<b>Title - Sujet</b> Mixing Box Replacement	
<b>Solicitation No. - N° de l'invitation</b> 39903-150590/A	<b>Amendment No. - N° modif.</b> 004
<b>Client Reference No. - N° de référence du client</b> 39903-150590	<b>Date</b> 2015-07-10
<b>GETS Reference No. - N° de référence de SEAG</b> PW-\$PWY-026-7536	
<b>File No. - N° de dossier</b> PWY-5-38049 (026)	<b>CCC No./N° CCC - FMS No./N° VME</b>
<b>Solicitation Closes - L'invitation prend fin at - à 02:00 PM on - le 2015-07-22</b>	<b>Time Zone</b> Fuseau horaire Pacific Daylight Saving Time PDT
<b>F.O.B. - F.A.B.</b> <b>Plant-Usine:</b> <input type="checkbox"/> <b>Destination:</b> <input checked="" type="checkbox"/> <b>Other-Autre:</b> <input type="checkbox"/>	
<b>Address Enquiries to: - Adresser toutes questions à:</b> Liu (PWY), Patty	<b>Buyer Id - Id de l'acheteur</b> pwy026
<b>Telephone No. - N° de téléphone</b> (604) 775-6227 ( )	<b>FAX No. - N° de FAX</b> (604) 775-6633

## Amendment 004

#### Mixing Box Replacement CFIA Burnaby Laboratory, Burnaby, BC

## GENERAL

Drawing M3.0

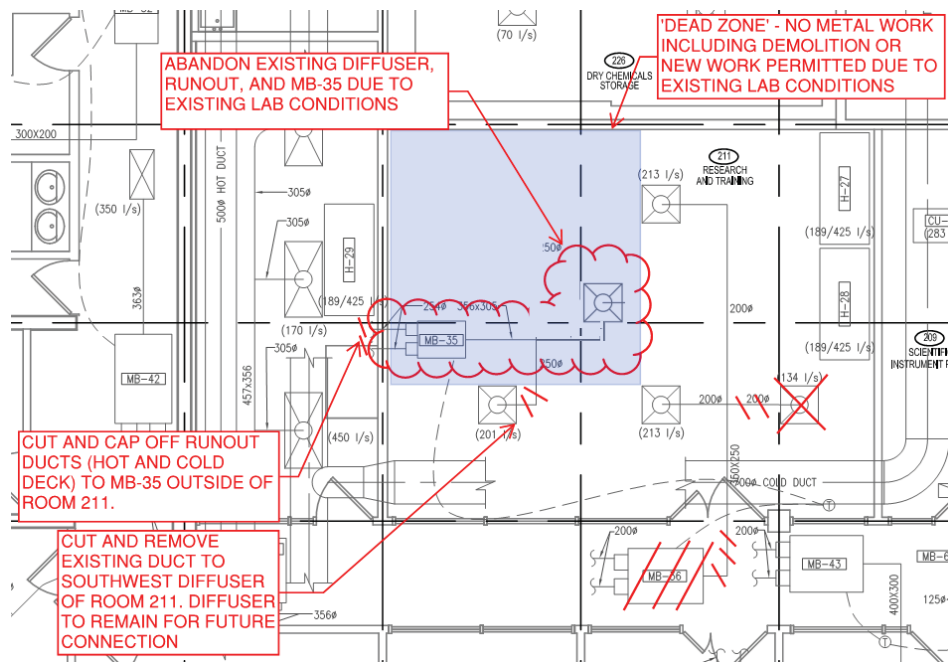
Amendments to this drawing for room 211 as per below sketch.

Drawing M4.0

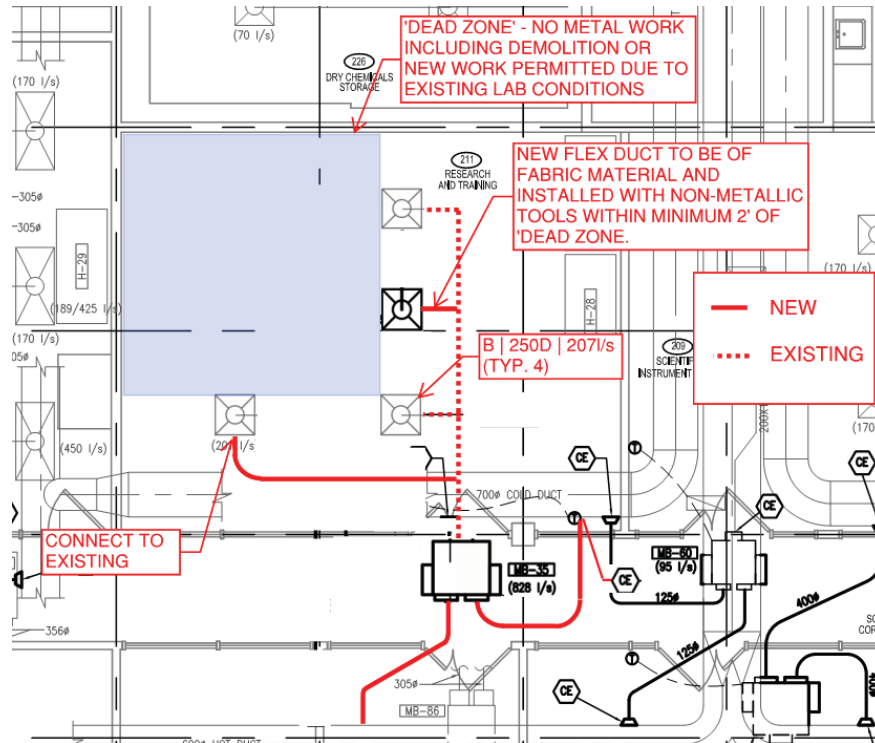
Amendments to this drawing for room 211 as per below sketch.
